# PRODUCT SUPPORT BULLETIN

## BULLETIN NO. 304

MACHINE: **Model C Spike Driver**  
**Model 99C Spike Driver**  
**M3**

SUBJECT: **Improved Turck Box Tee Connector - 58050004**

**New Connecting Tee**

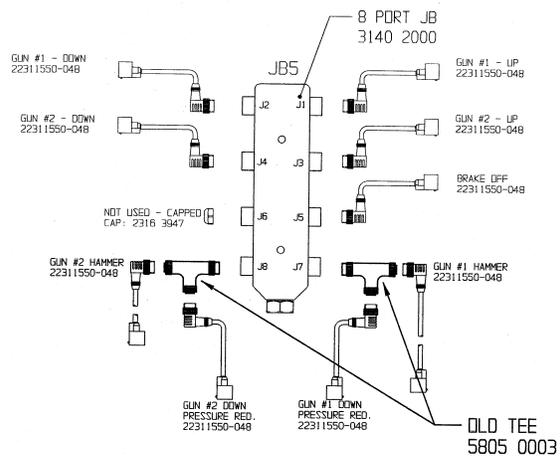
A new style Connecting Tee, part number 58050004 is replacing the 58050003 Connecting Tee on the Turck Junction Boxes. The 58050004 Connecting Tee has a 90-degree end where it connects to the Turck Junction Box with the tee at the end of an 8" pigtail. See illustration below.

If the 58050003 Connecting Tee is bumped or leaned on, the pins in the tee may break. With the new 58050004 Connecting Tee, the DIN cables will be connected to the end of the pigtail and can be tie-wrapped to the cable bundle behind the Turck Junction Box mounting. This will reduce the chance of the tee being damaged.

When the 58050003 tee is ordered it will be replaced with the 58050004.
